Dresden Nuclear Power Station, Units 2 and 3  
Facility Operating License Nos. DPR-19 and DPR-25  
NRC Docket Nos. 50-237 and 50-249

Subject: Revision to Unit 2 and Unit 3 Cycle 17 Core Operating Limits Report

# **Core Operating Limits Report**

## ISSUANCE OF CHANGES SUMMARY

FIGURE 2.2-1

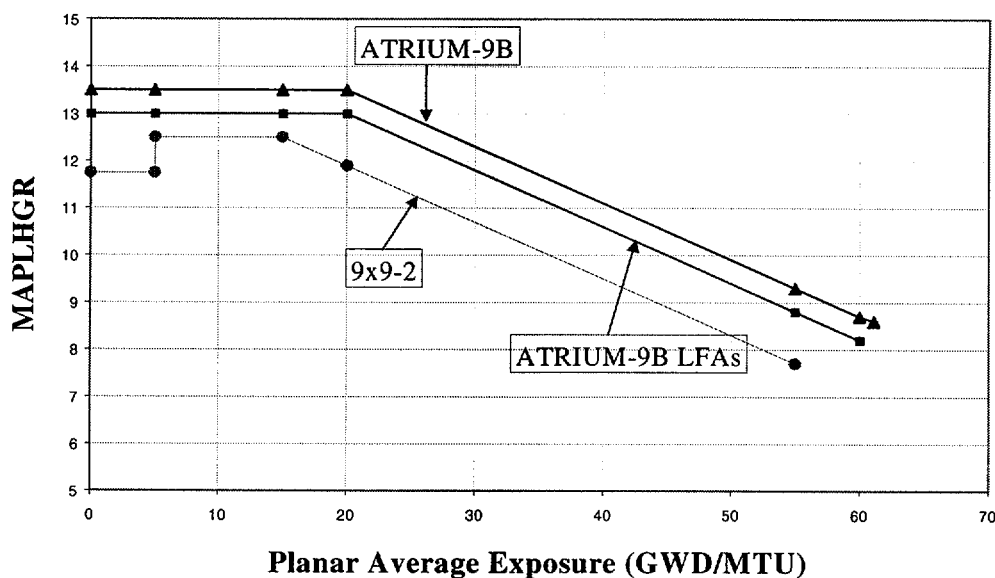
Affected Section	Affected Pages	Summary of Changes	Date
All	All	Original Issue Cycle 17	10/99
Figure 2.2-1	2-2	Figure 2.2-1 and the table below the figure were revised to reflect how the limits are implemented into the core monitoring code <sup>1</sup> .	10/12/99

**FIGURE 5.2-1**

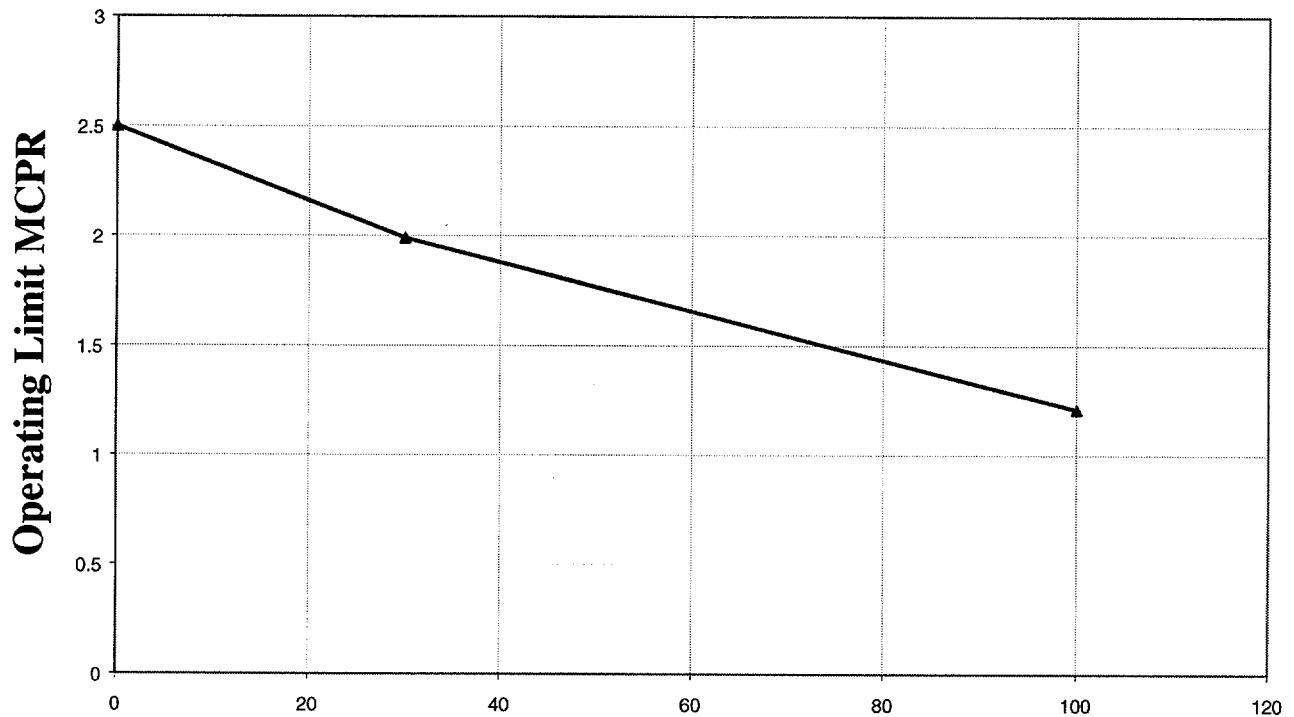
1.1, 2.1, Table 2.3-1, 3.1, 4.1, 5.1, 5.2.a, Figure 5.2-1, 6.1	1-1, 2-1, 2-3, 3-1, 4-1, 5-1 5-4, 6-1	Include ITS in Technical Specification references	3/01
Methodology	6-1	Added references CTS 6.9.A.6.b.1-6.9.A.6.b.13 (ITS 5.6.5.b.1-5.6.5.b.13), including the reference revision number and date	3/01
